From: Griffin, Tim (Contractor)
Sent: 08 August 2024 13:24
To: Altman, Rebecca
Cc: Dyer, Tim; Ellison, Mark; Oliveira, Marta (Contractor); Stringer, Chris; Boyd, Sarah
Subject: Re: F/24/97312 Land adj. 4 Brookfield, Providence Hill - amended landscape information - further landscape comments

I have downloaded and reviewed the latest amended landscape related information for this site.

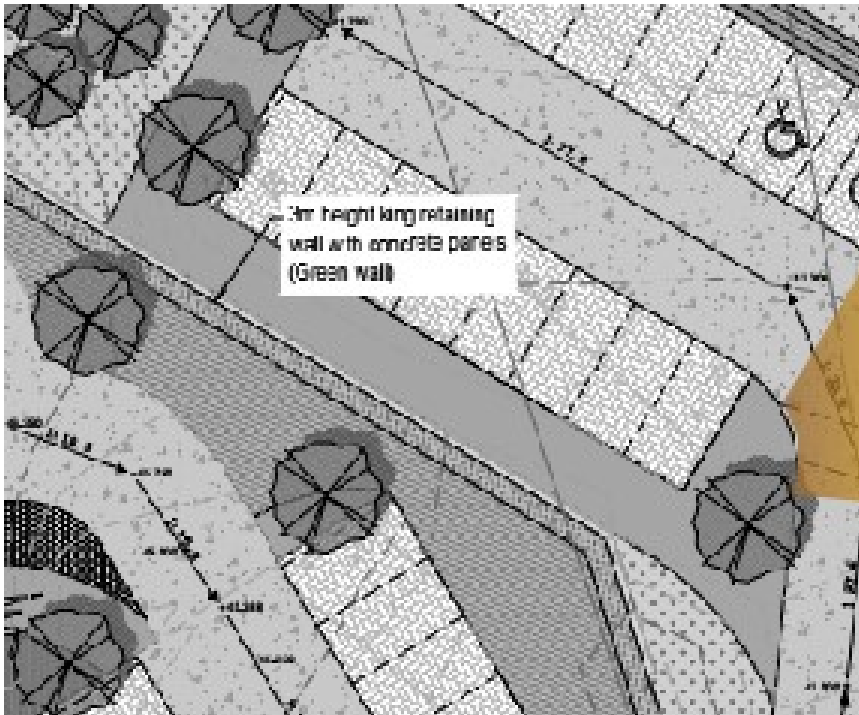
d/ There are considerable stretches of 3m high king post retaining walls. The plan notes this with concrete panels/green wall. The detailing of this is critical and we would ask for a detailed cross section to ensure we are comfortable that on construction the effect will truly be a green wall. This may include the need for drip irrigation until the green wall is established. At present, I could not see any planting indicated on plan to create the green wall effect? The clipped hedge along the top of part of this retaining wall has not been noted on plan or on the key.

Please clarify what treatment is proposed along the top of the retaining wall in this location:

A 1.8m cbf would not be acceptable with a hedge preferred. For H & S a guard fence can be included running along the centreline of the hedge. This may be a post and steel stockproof fence to avoid a visually 'heavier' detail.

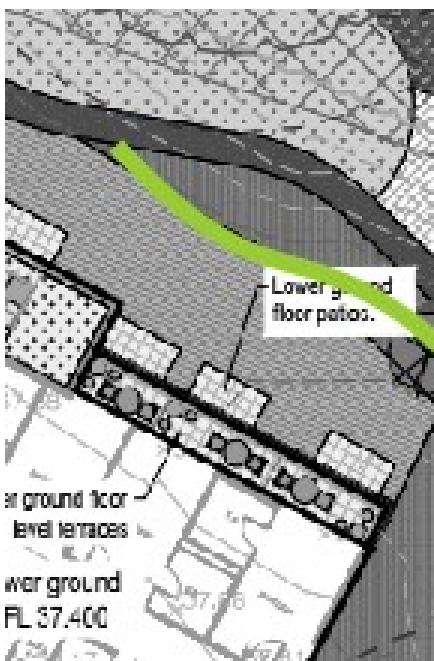
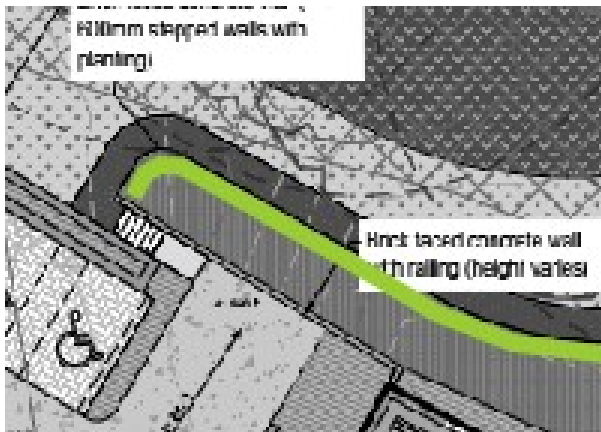
g/ I would suggest it is a mistake to break the mixed scrub planting here:

Views from the north into the site should be softened here with new scrub planting. Please rearrange the planting in the buffer strip to close this gap.

Although all planting details will be conditioned, please change note to read 'New *native* scrub planting'.

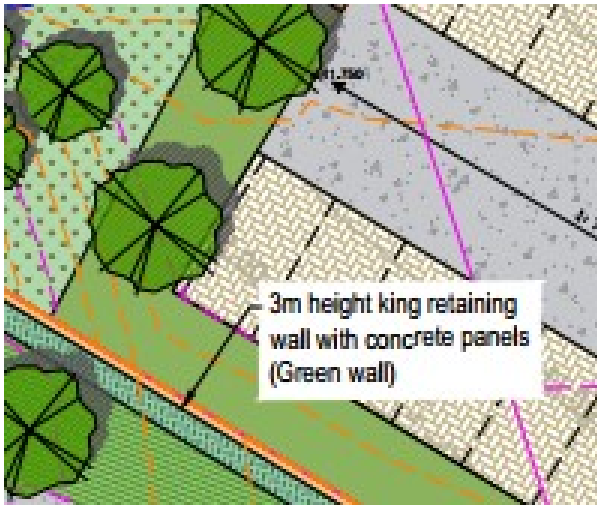
k/ There are other areas on site where clipped hedges could be included. Hedges are a neat element that provide planted areas with structure and all landscape maintenance teams find easy to maintain. For example, the native shrub planting shown in the locations below could establish as a pretty untidy areas of planting. I suggest some native mix clipped hedges to provide structure/neat edges to these areas:
